#2016-10 Kensington Subdivision – Rezoning, Comprehensive Plan Amendment, Preliminary Plat, Preliminary PUD and Variations Project Review for Planning and Zoning Commission

Meeting Date: April 20, 2016

CITY OF CRYSTAL LAKE

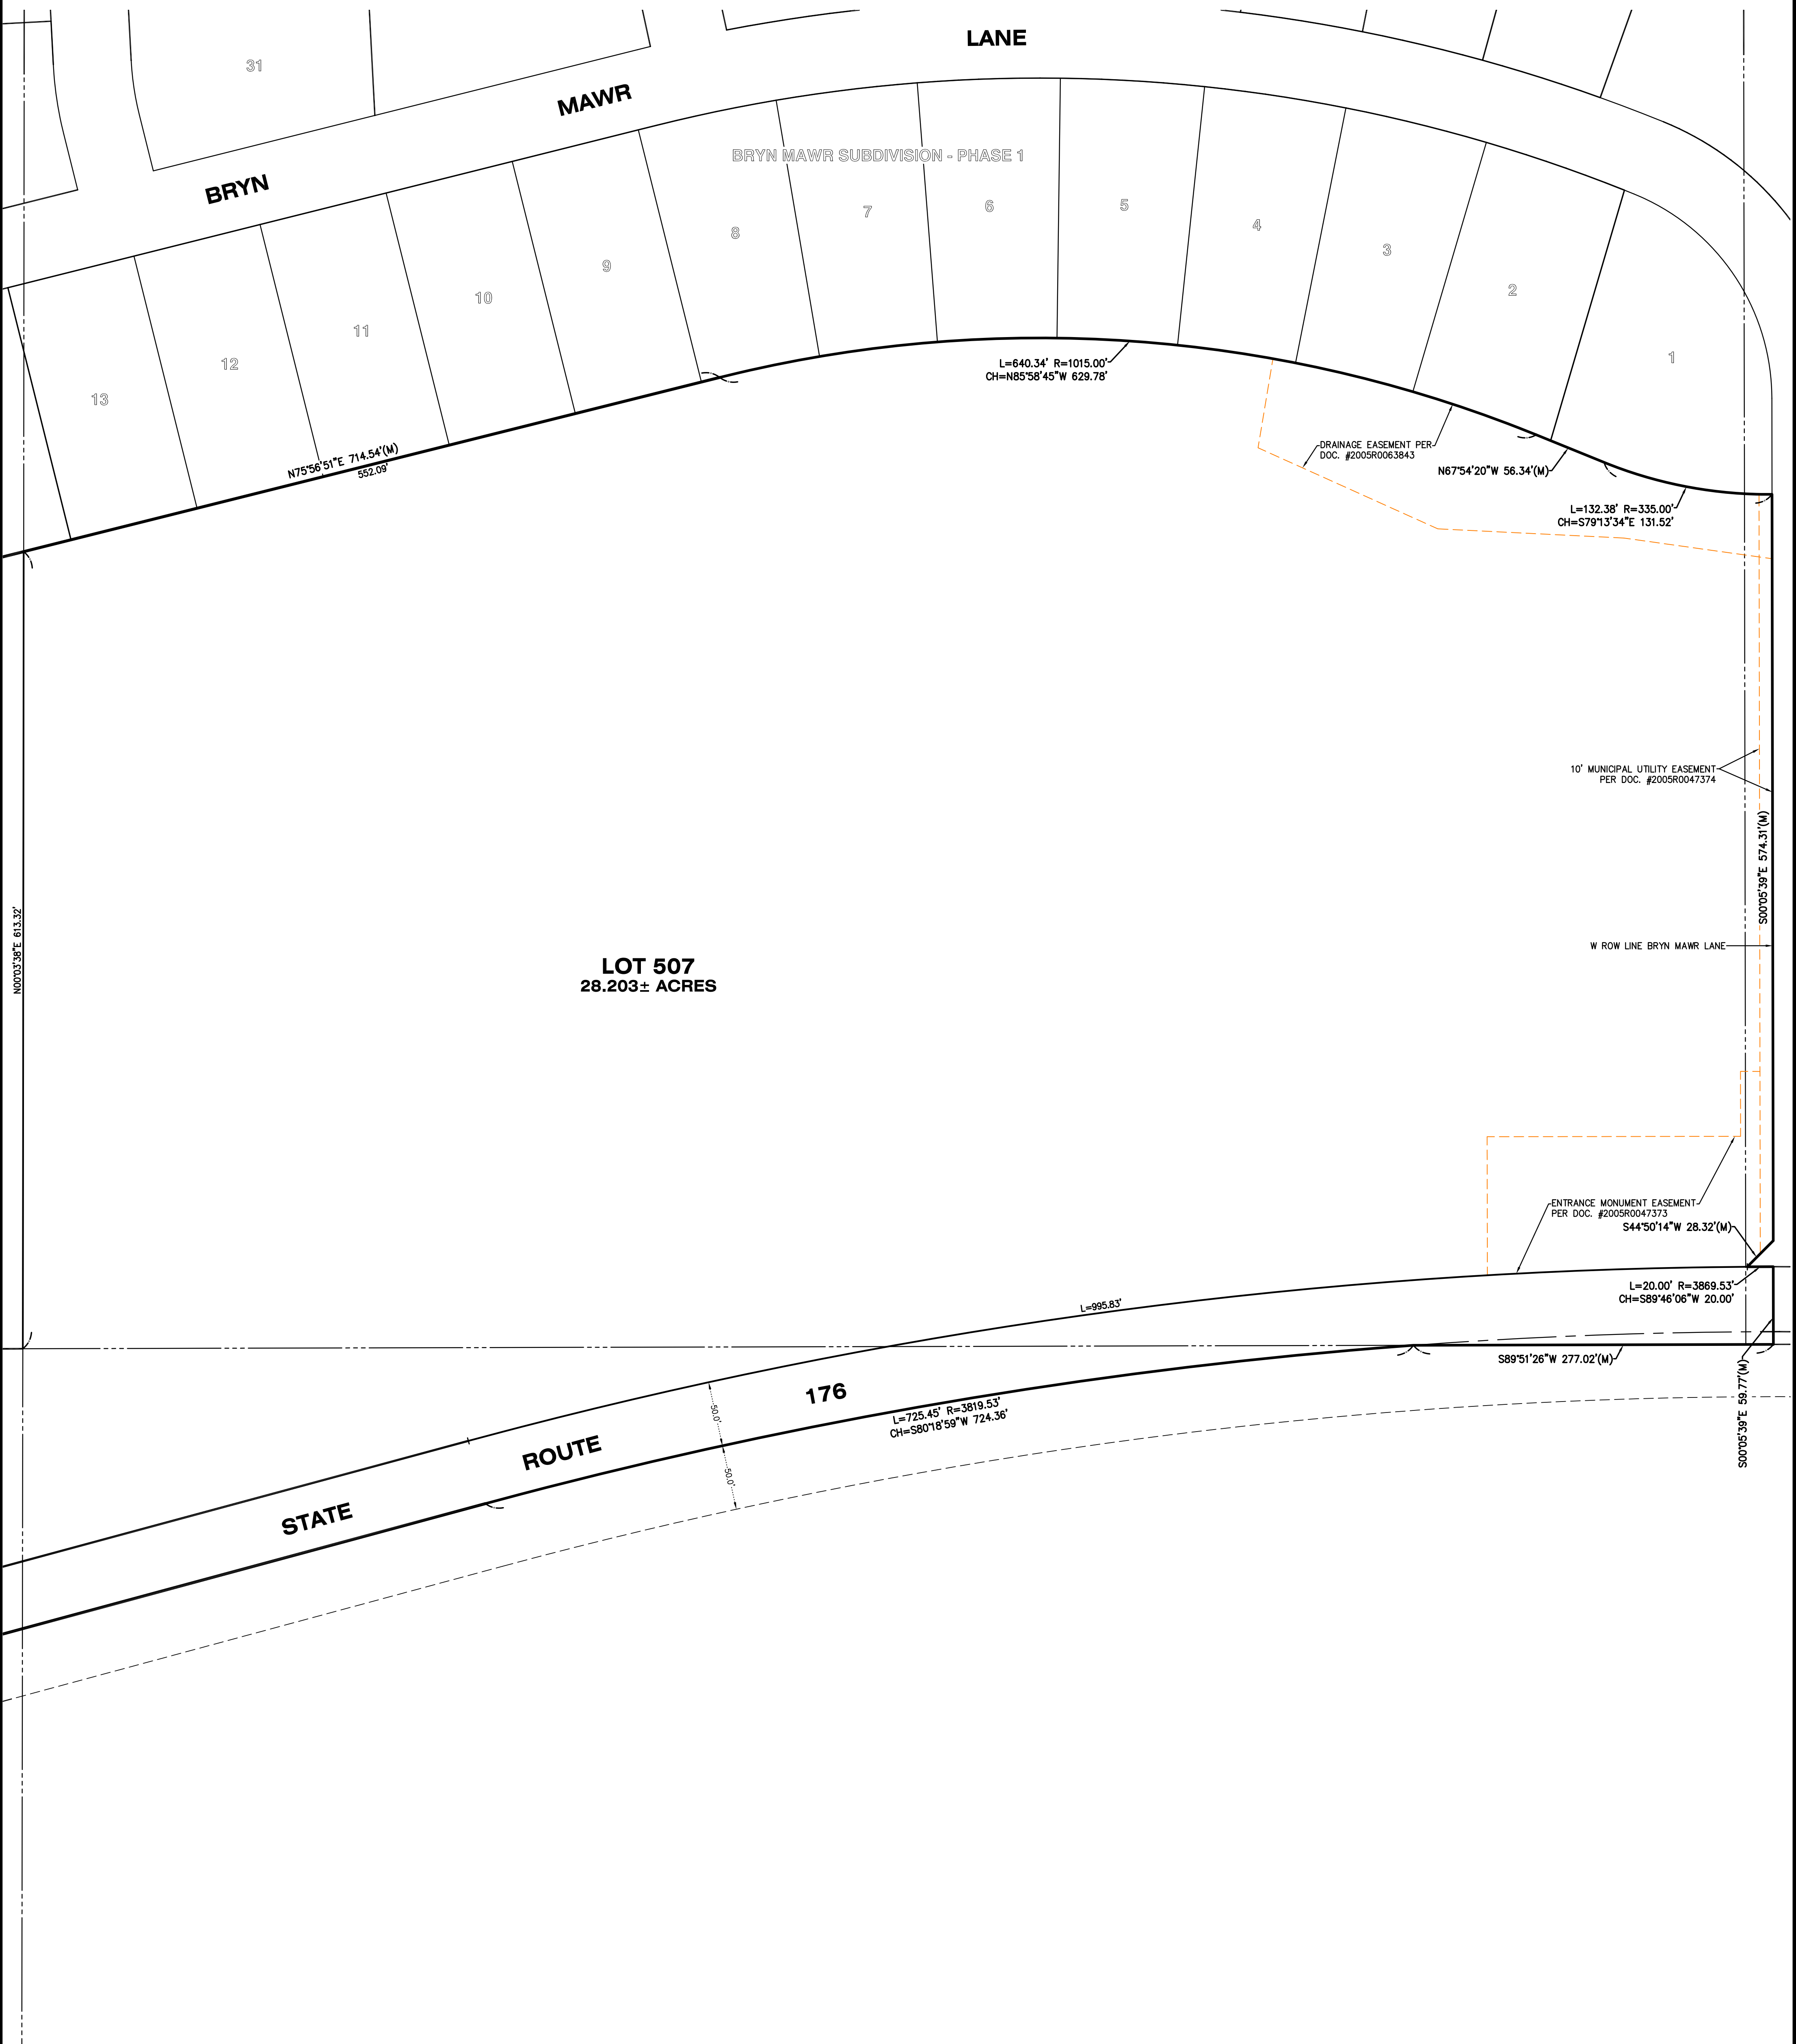
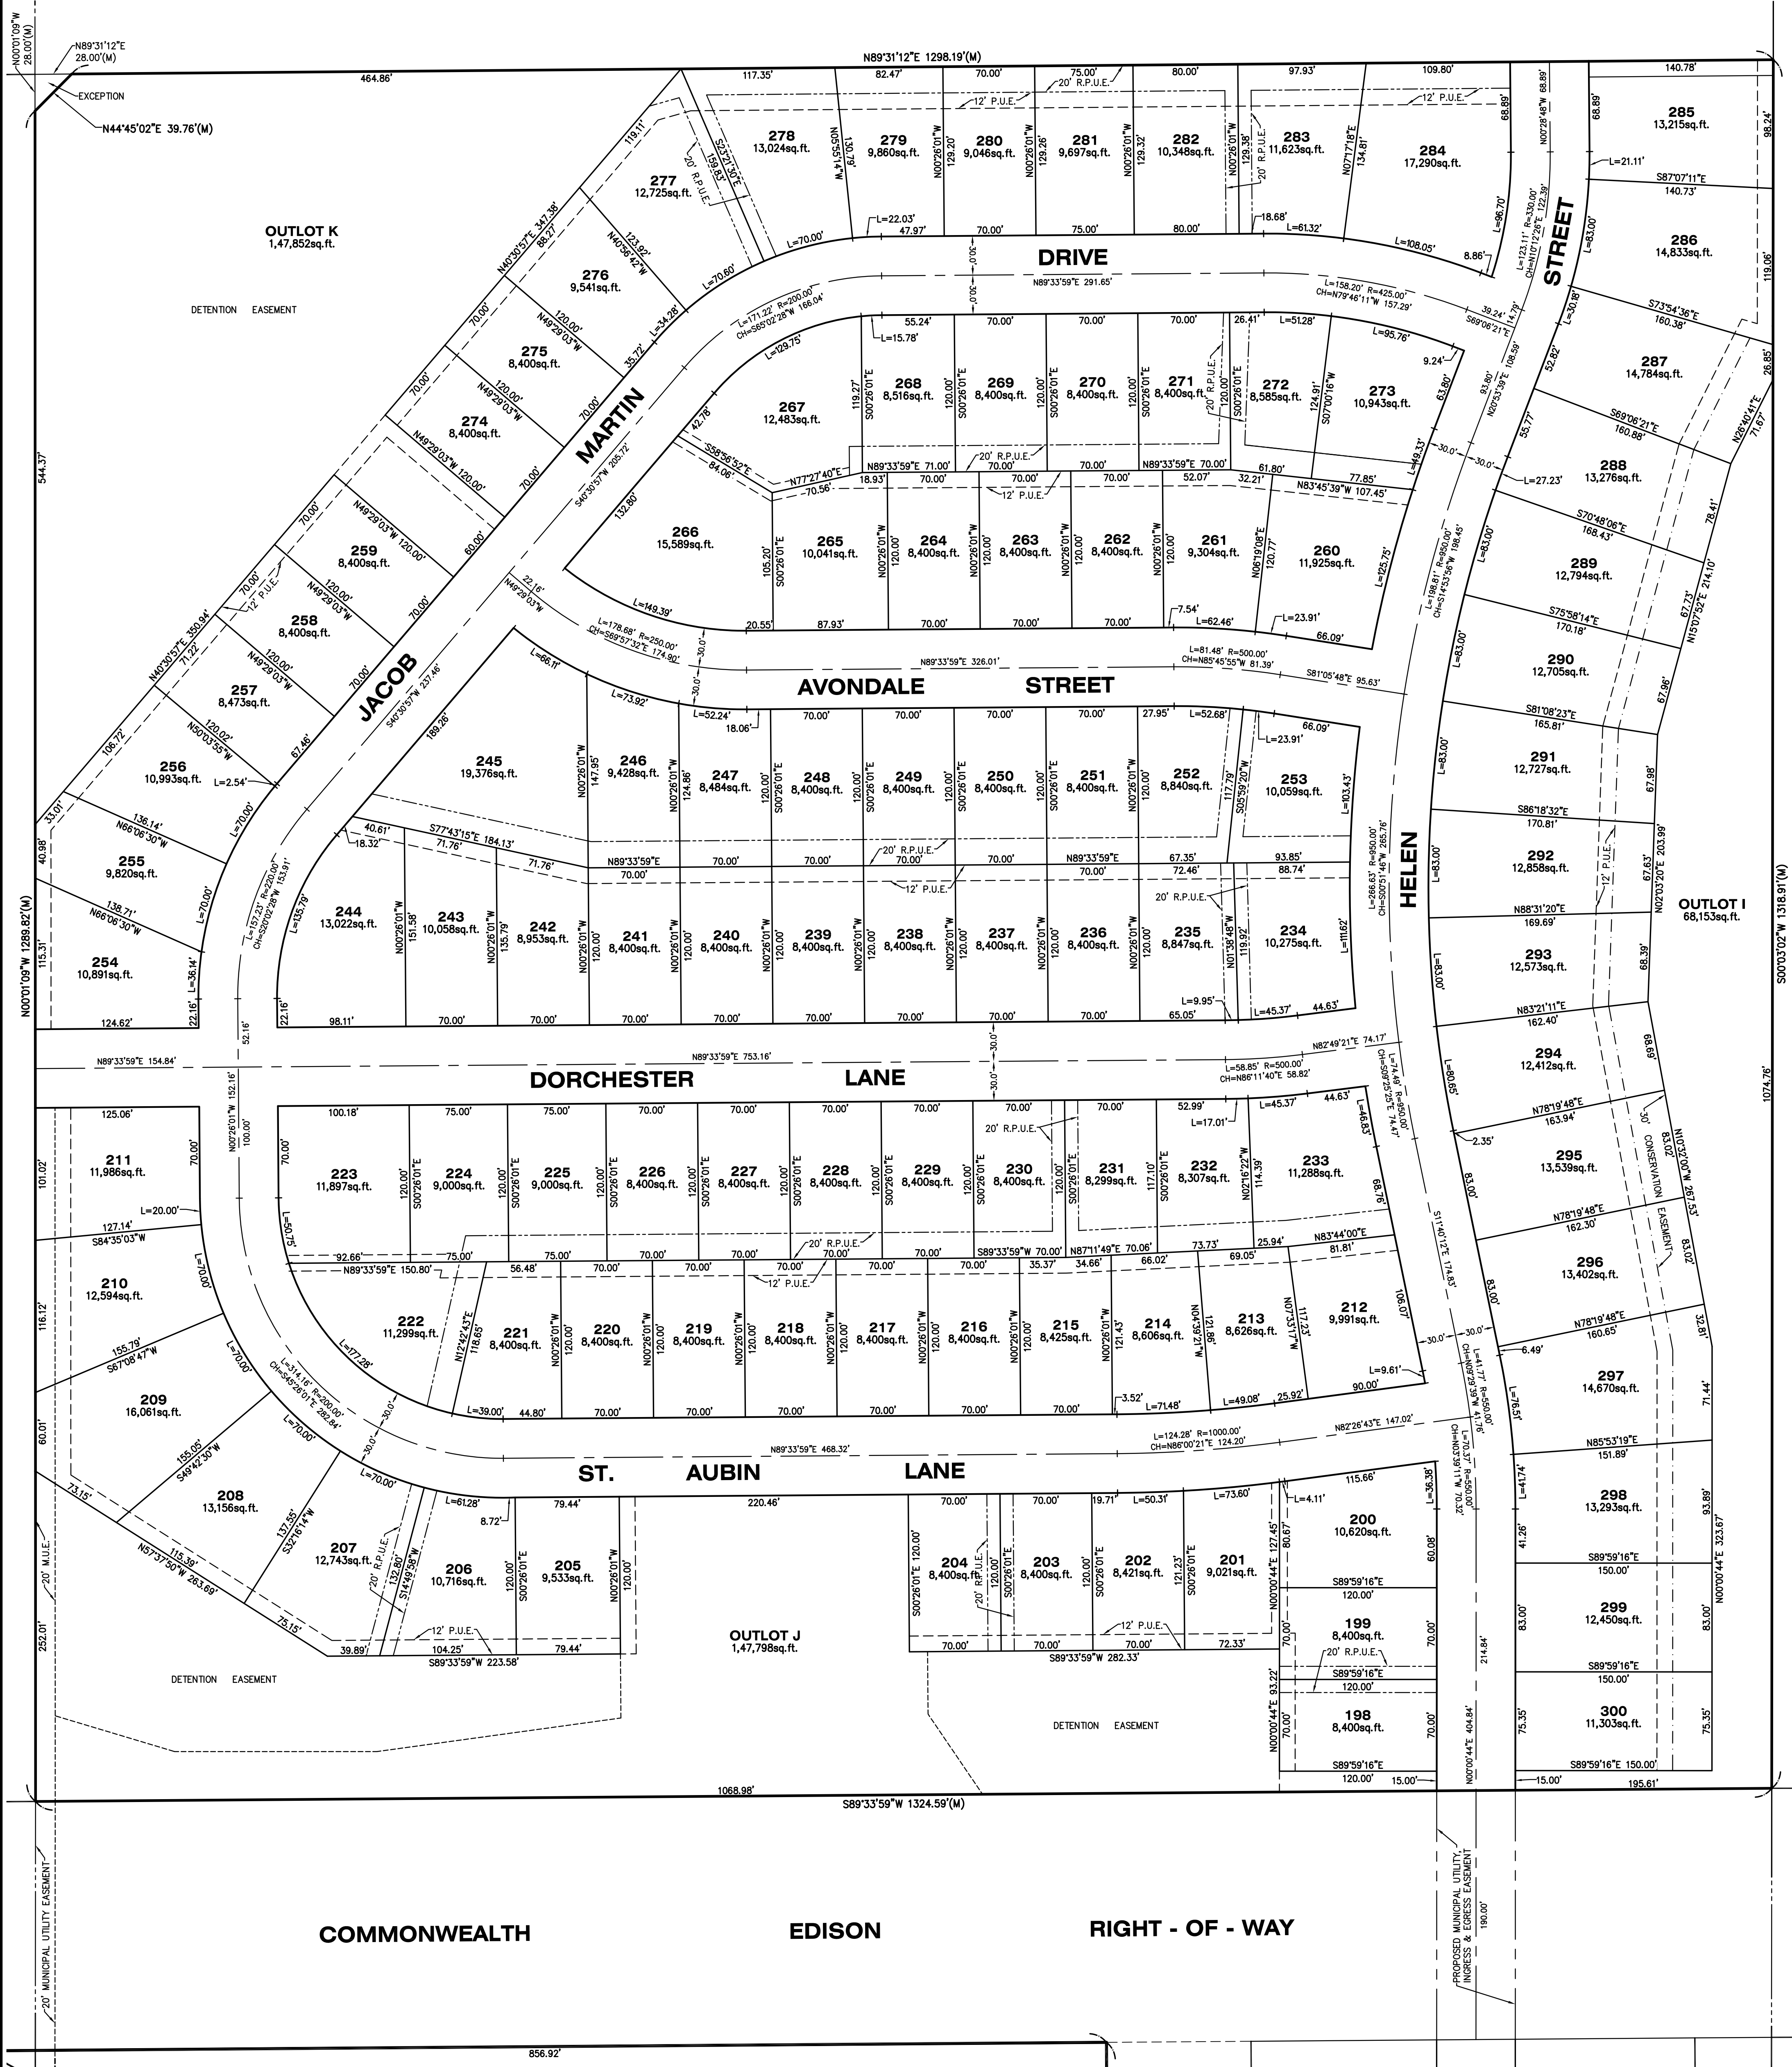
- R. Tree Survey (Urban Forest Management, dated 03/29/16, received 03/29/16)
2. Preliminary Plat of Subdivision:
 - A. Add notations to all roadways on the plat, "hereby dedicated" for the public roadways and "private drive" for private roadways.

- B. Add notations to previously dedicated roadways.

- C. Public streets must be 28 feet wide, measured edge to edge, with a 2-foot shoulder striped on each side instead of the ribbon curb.
 - D. The private streets for the townhomes shall have street names that will be approved by the Fire Rescue Department. Each separate section of townhomes should have a different street name.

- E. Kensington Court is not an approved street name. Provide an alternate name for consideration.
 - F. The new Fabius Street section will need to be renamed since the existing Fabius Street will not be extended. Provide an alternate name for consideration.

- G. Bryn Mawr Lane shall end at the intersection with Helen Street (east side) and the remainder of the street shall be renamed the alternate name as required in condition 2.D.

- H. Eliminate the driveway access to Bryn Mawr Lane between townhomes 459 and 470.
 - I. Provide cross connection between townhomes 474-437 the two townhome groupings with a private access.

- J. The emergency access to the portion of the subdivision located north of the ComEd easement shall 20 feet in width, constructed with an approved surface and must be maintained by the HOA. Gates at both ends are required to restrict motorized use and must be approved by the Fire Chief.

- K. Each outlot should be labeled with the intended use, “conservation easement”, “drainage easement”, etc.
 - L. The interior of the roundabouts shall be outlots and maintained by the HOA.

- M. Lot 505 shall be renamed as Outlot L.
 - N. Lot 506 shall be renamed as Outlot M.
 - O. Adjust the townhome layout to provide guest parking for the townhome lots 399-512.

- P. The “unsubdivided parcel” to the north of Achilles Lane and adjacent to the edge of Bryn Mawr Phase I needs to be labeled as an outlot and included in the development.

- Q. The zoning district noted on the plat of subdivision is R-2, add PUD and include R-3B PUD and B-2 PUD.
 - R. Add building setback lines to all lots on the preliminary plat of subdivision.
